Photographs in Support of Wil Arnett Declaration

Submitted in Support of Oncor Electric Delivery Company's Reply Comments

April 22, 2008

Violations CATV / ILEC

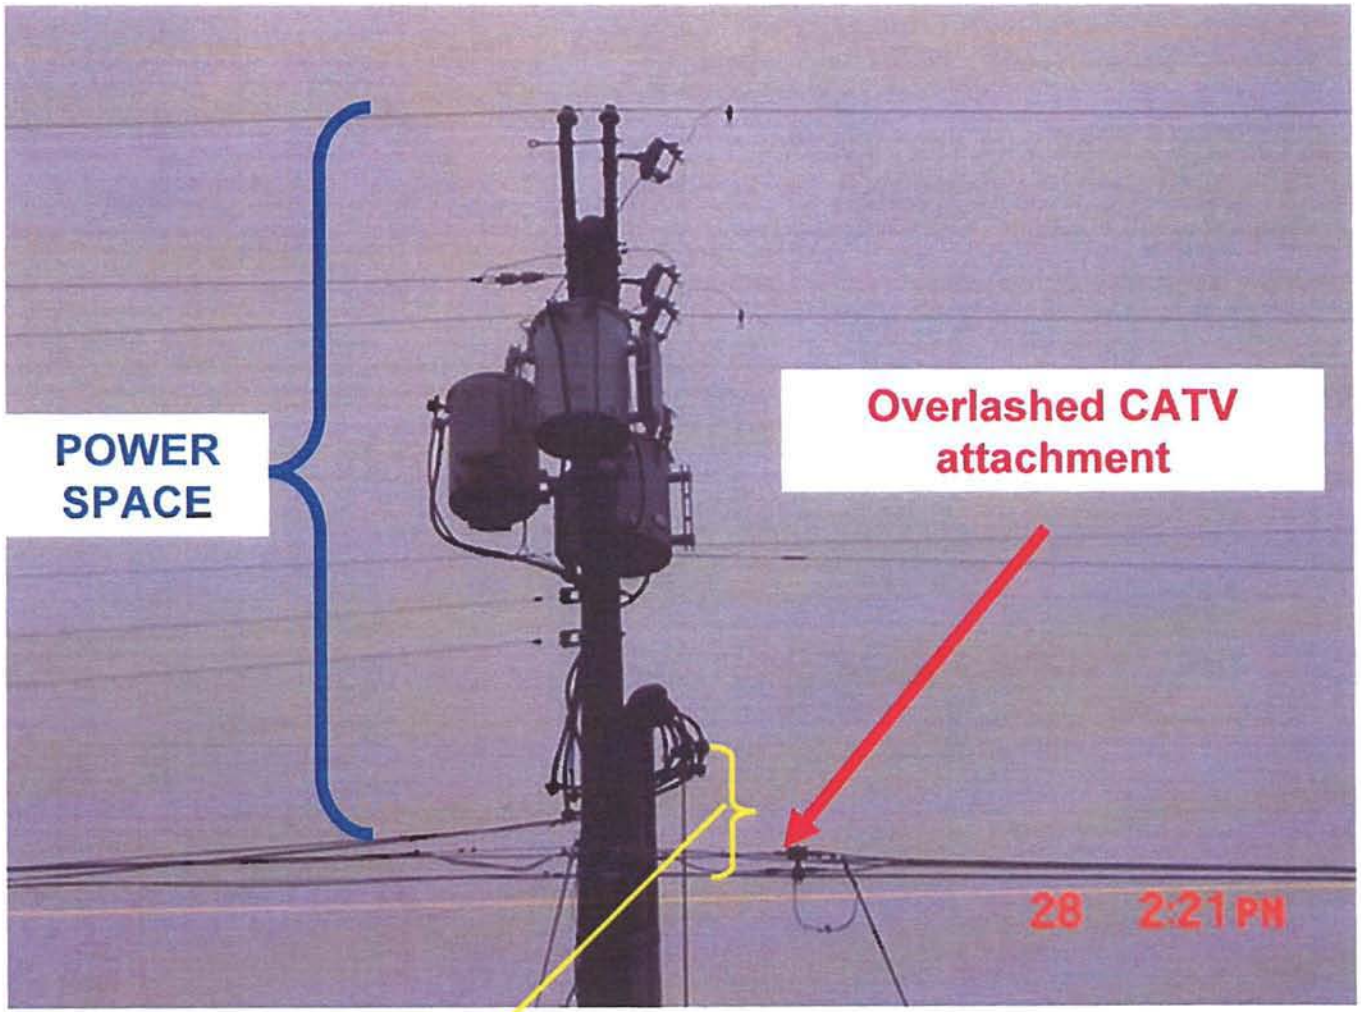
< 40 in separation =
NESC violation

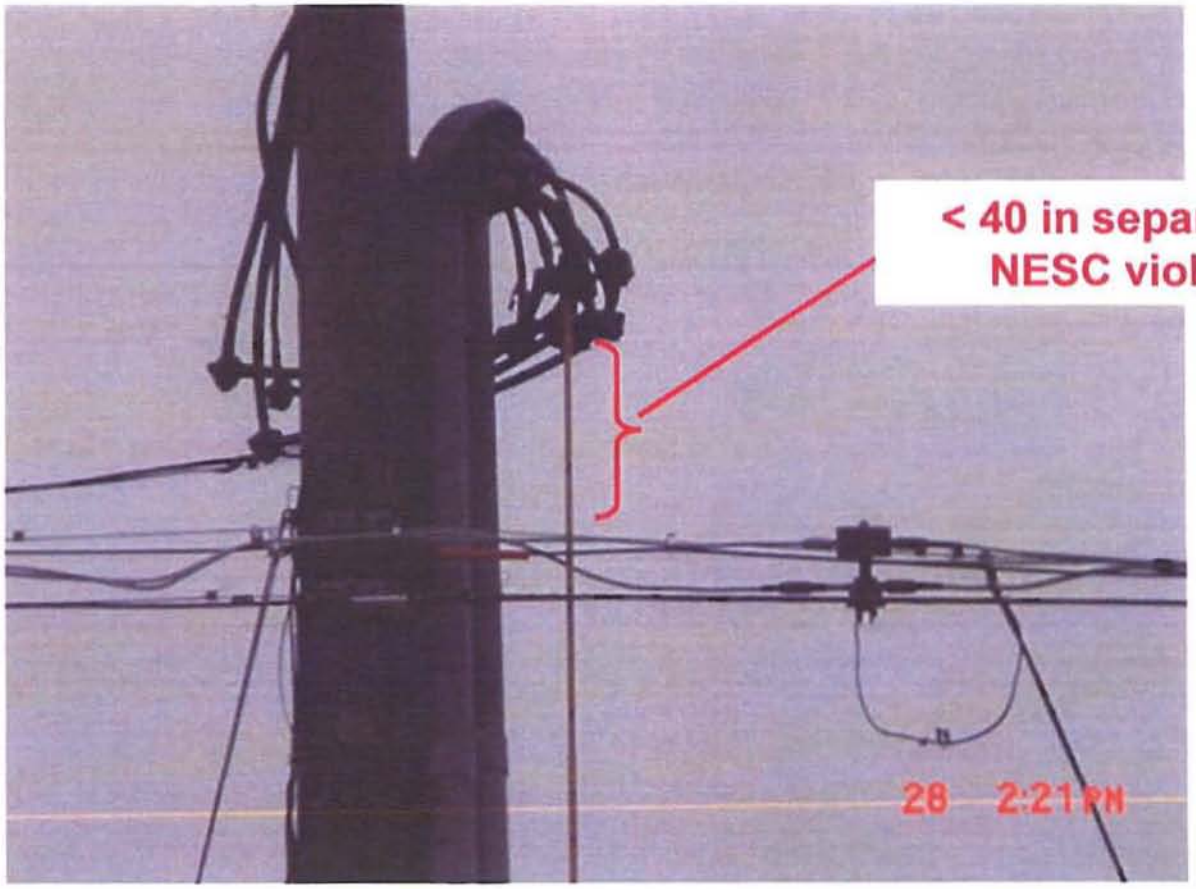
Close-up of previous slide

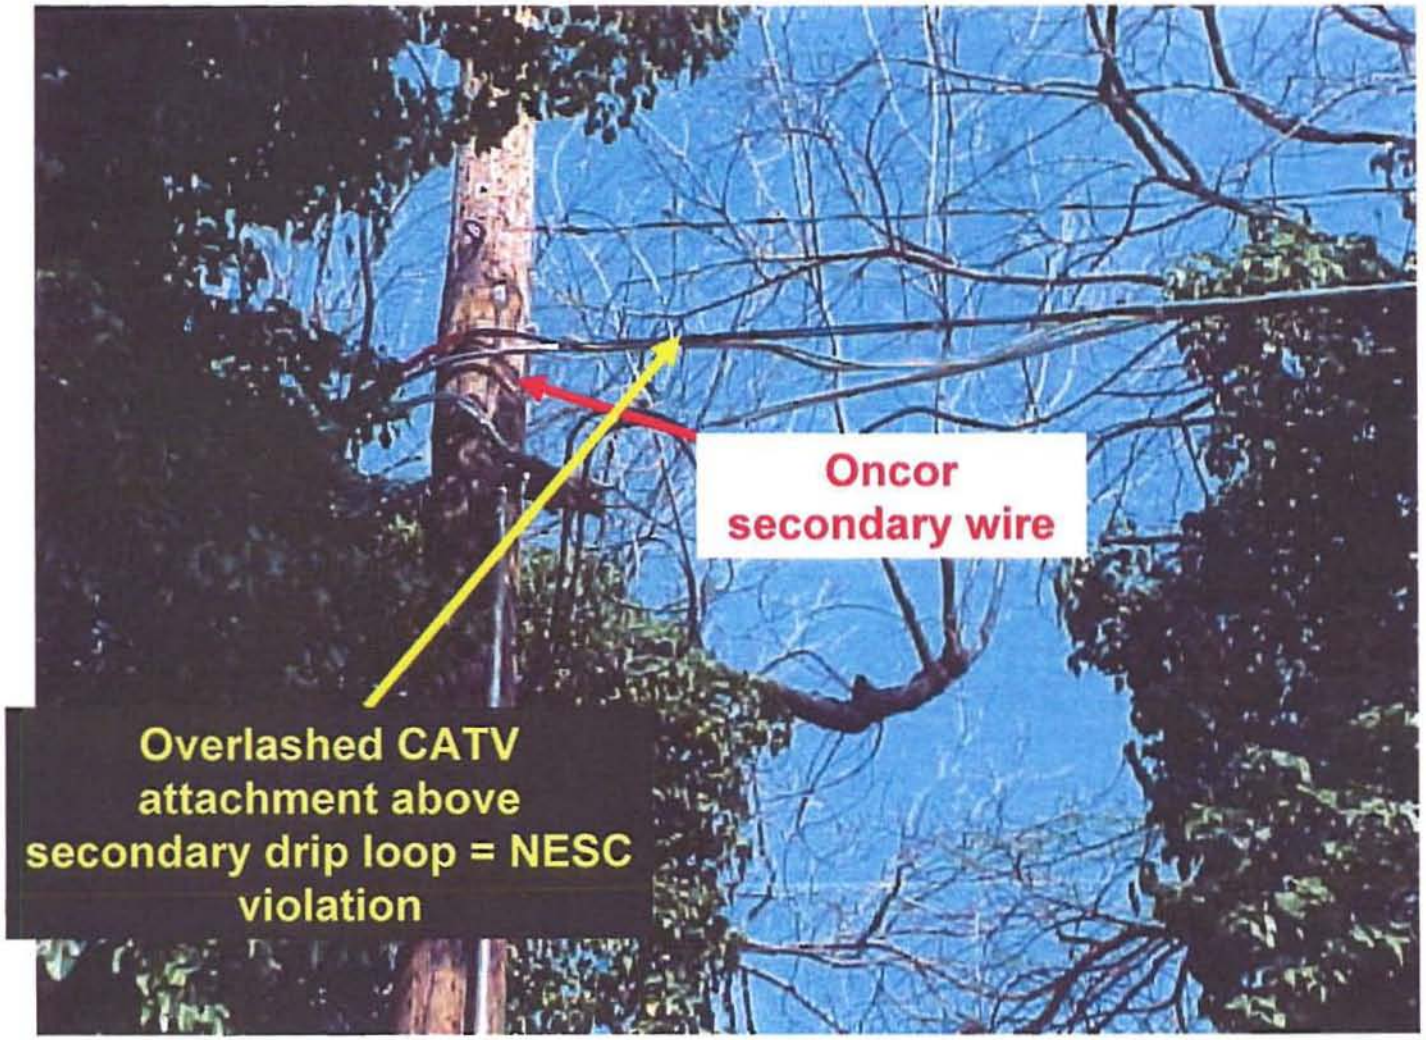
Oncor
secondary wire
Overlashed CATV
attachment above
secondary drip loop = NESC
violation

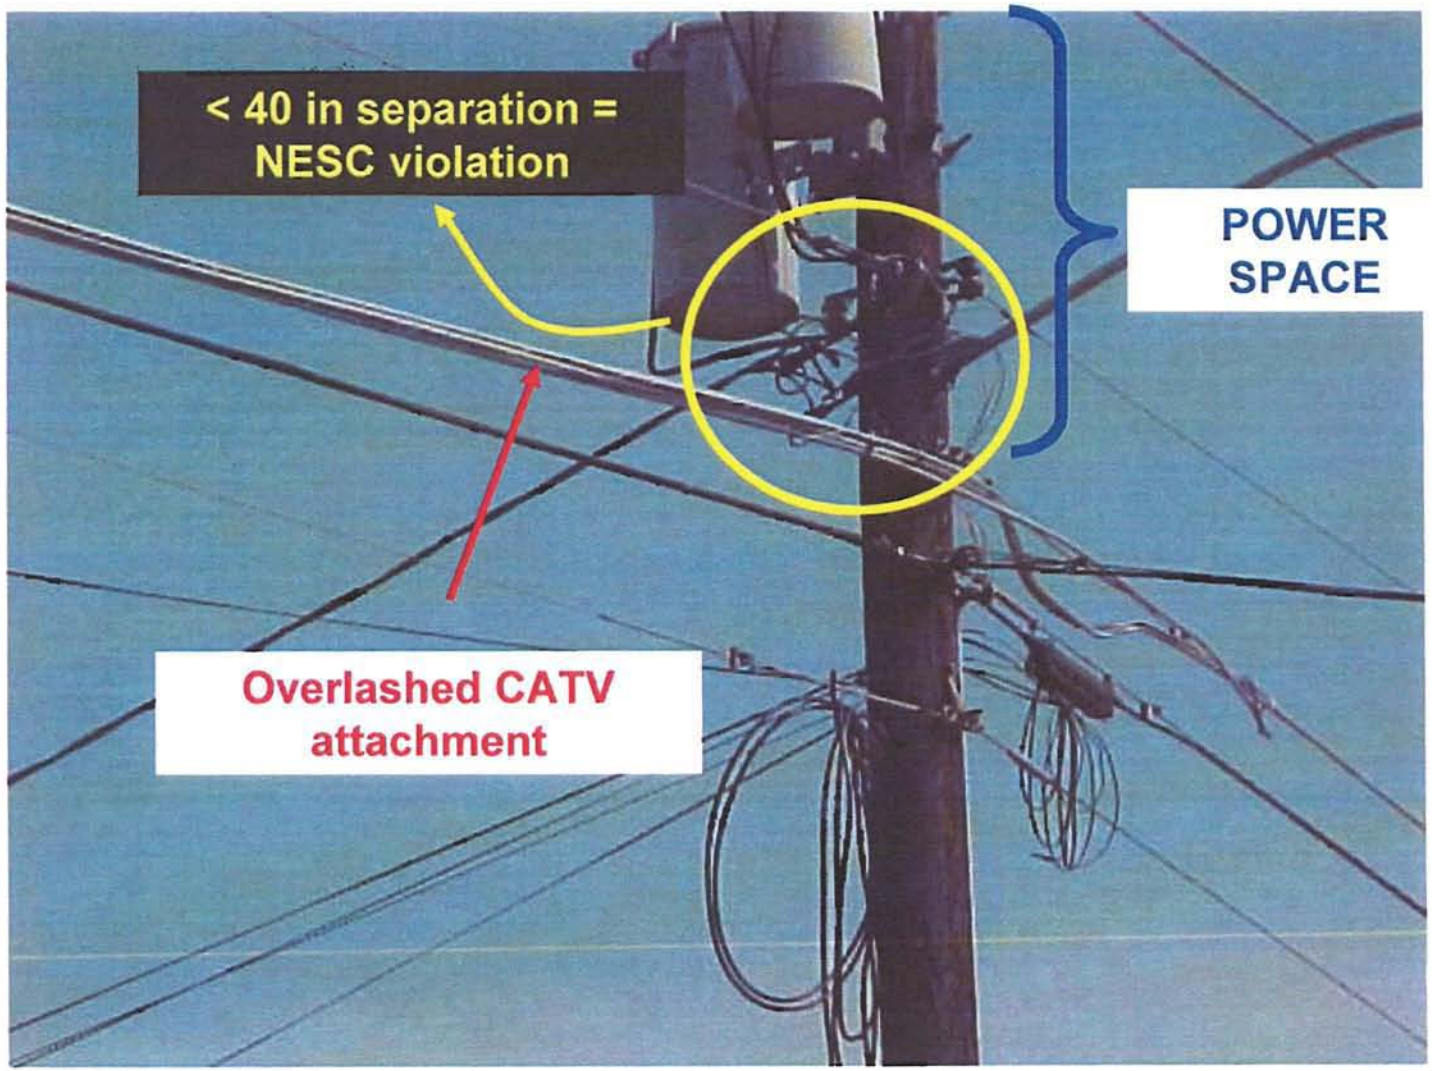
< 40 in separation =
NESC violation
POWER
SPACE
Overlashed CATV
attachment

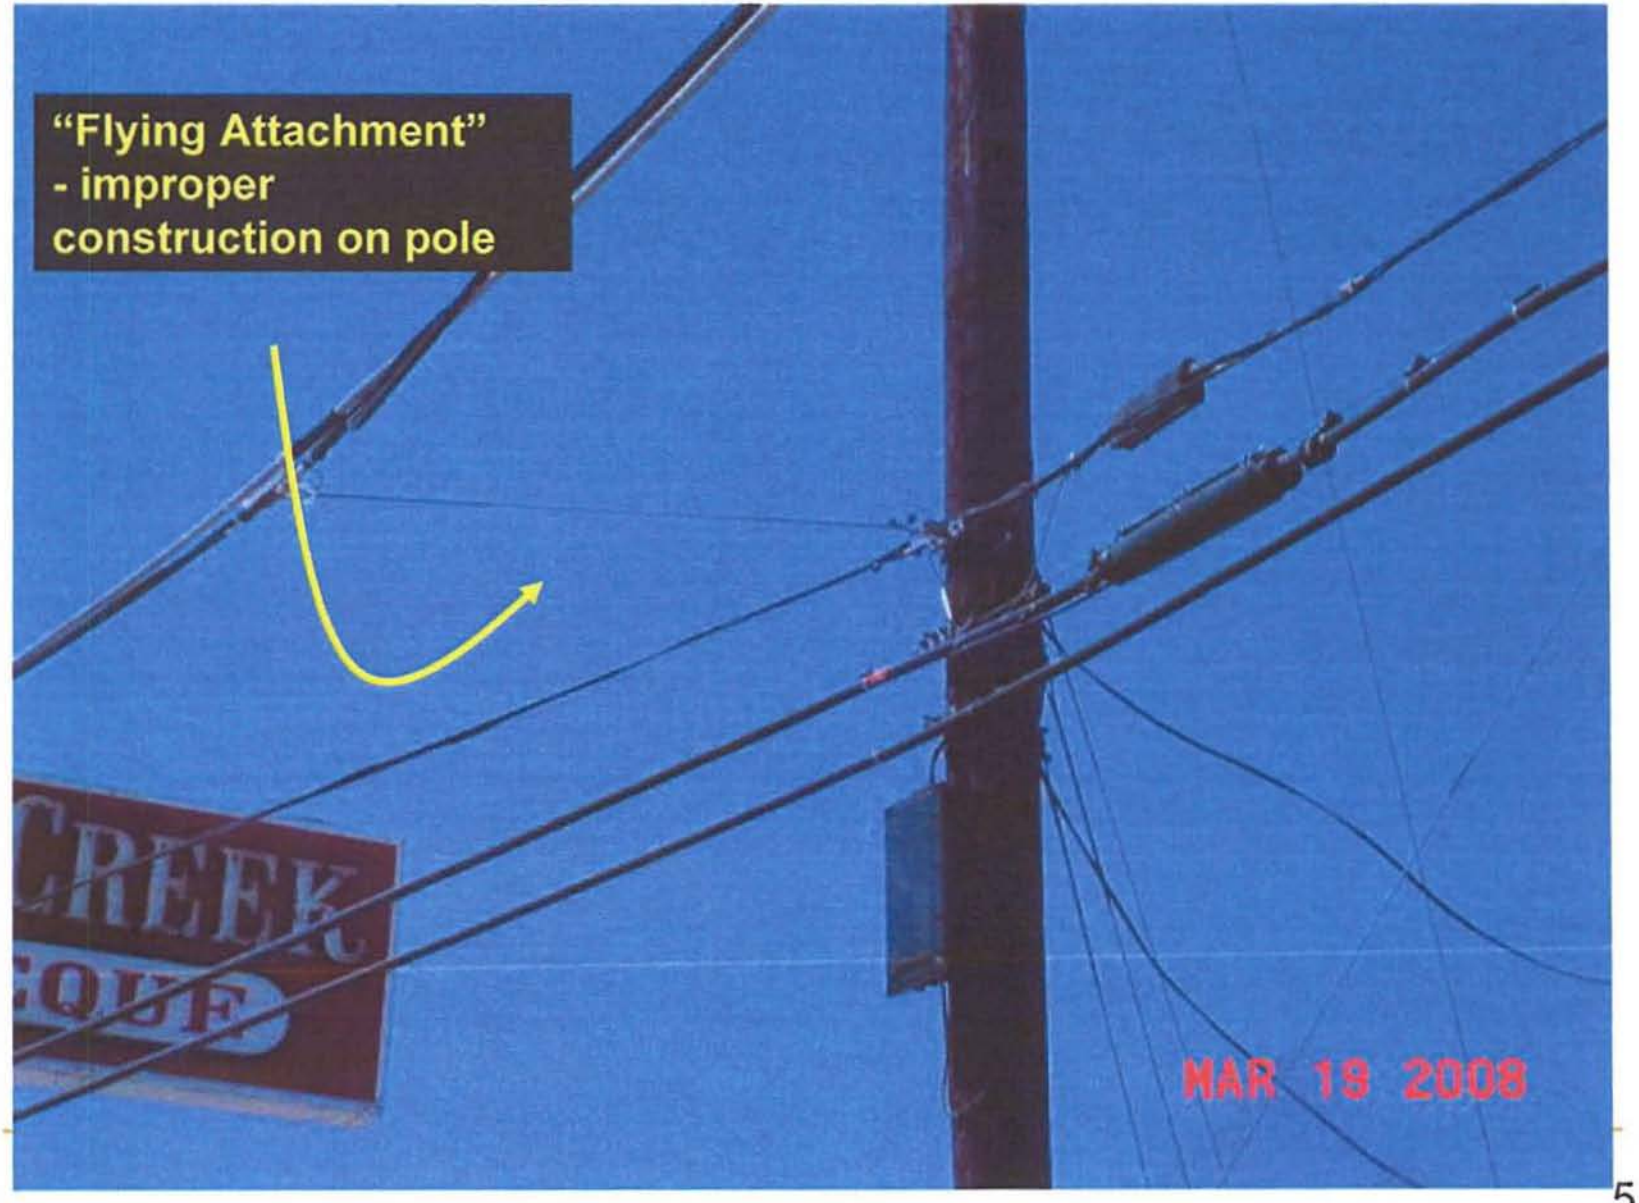
"Flying Attachment"
- improper
construction on pole
CREEK
GOLF
MAR 19 2008

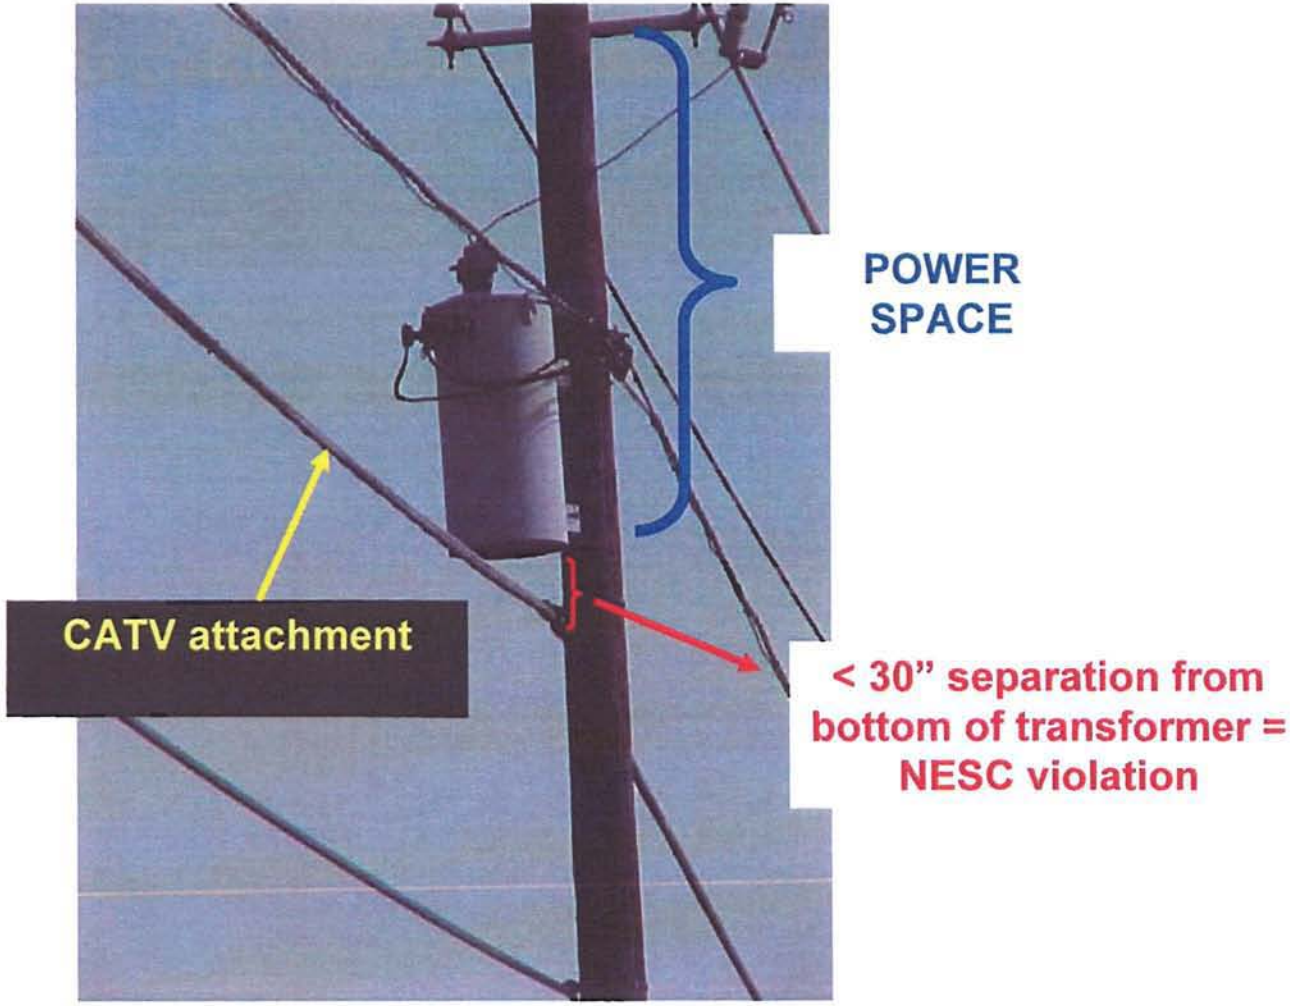
POWER
SPACE
CATV attachment
< 30" separation from
bottom of transformer =
NESC violation

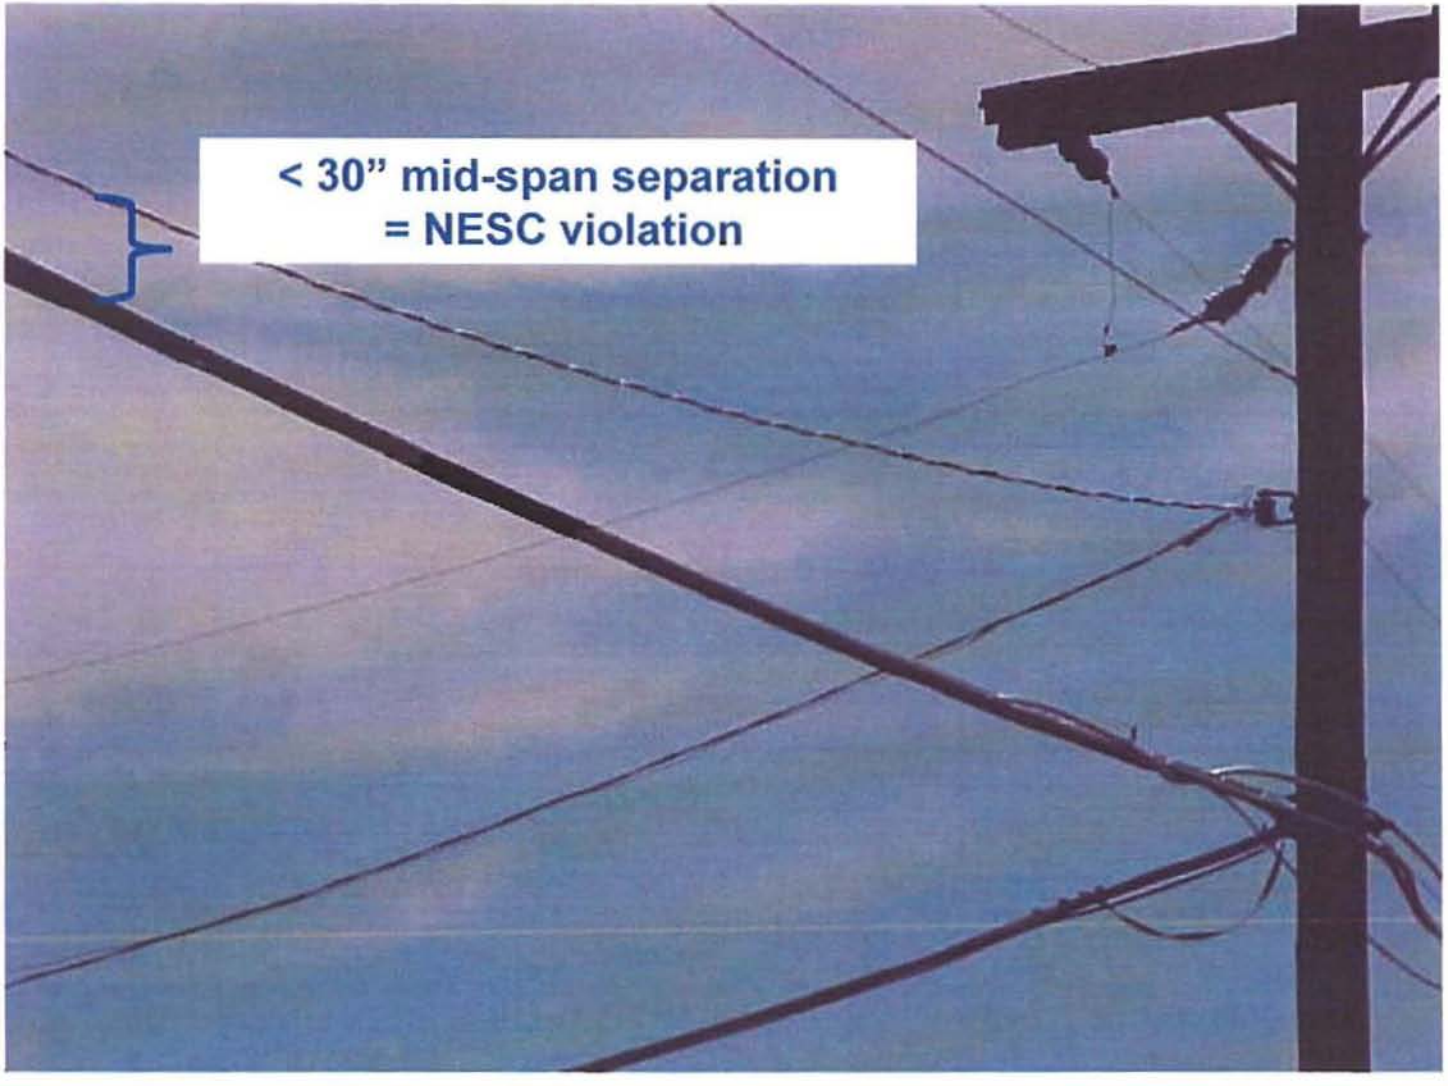
< 30" mid-span separation
= NESC violation
